MEMORANDUM

TO: Madeleine Reinke, Kimley-Horn and Associates, Inc.
FROM: Cynthia Thye, Planner 1
DATE: December 31, 2025
SUBJECT: SP25-119: Lincoln Professional Park L2 - 7 Brews Coffee – Site Plan Review Comments 02

FILE: XXX
DRAWN BY: TFS
CHECKED BY: AMF
PROJ. NO.: 04022194
DRAWING NO.: **SE1.1**

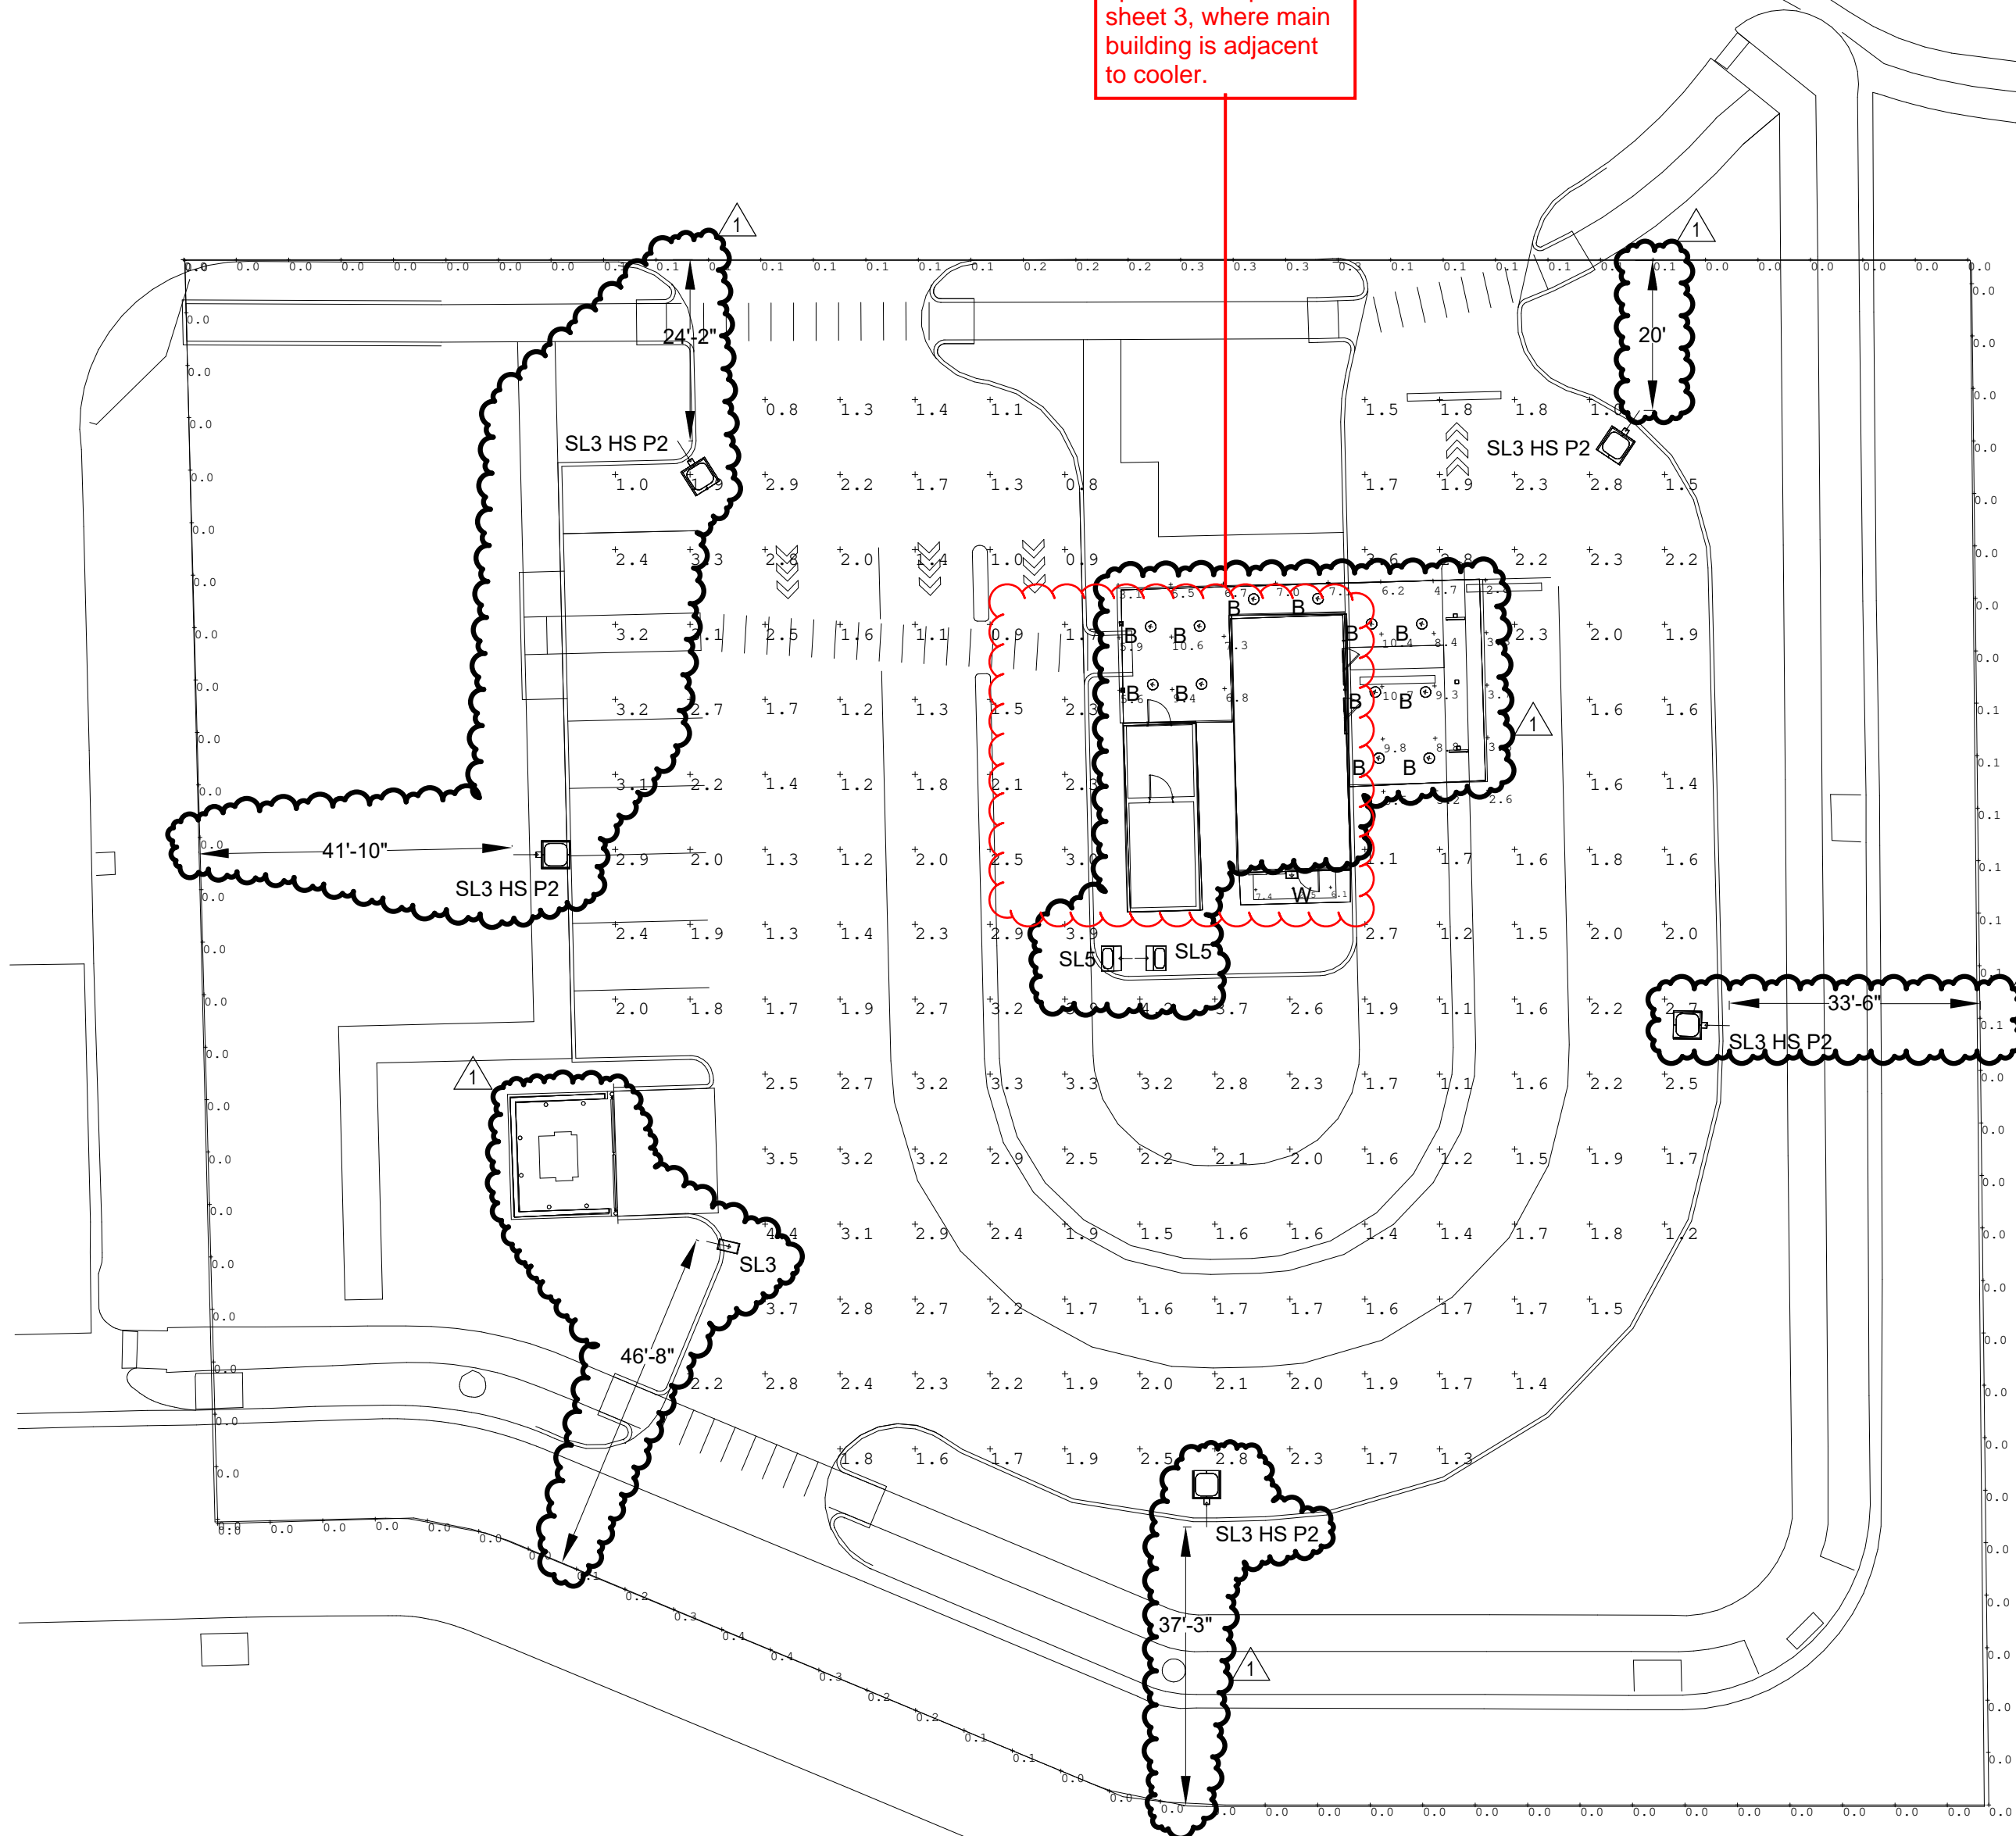
15. Revise plan to match updated site plan sheet 3 where main building is next to cooler.

16. Per LDO 13.08.110(e)(2).a., add correlated color temperature of each fixture to table. Must be below 5001 degrees Kelvin.

17. Add color of each fixture to table, unless on ceiling of canopy. Must be black or bronze.

Add color of each fixture. Unless on ceiling of canopy need to be black or bronze.

Revise to match updated site plan sheet 3, where main building is adjacent to cooler.
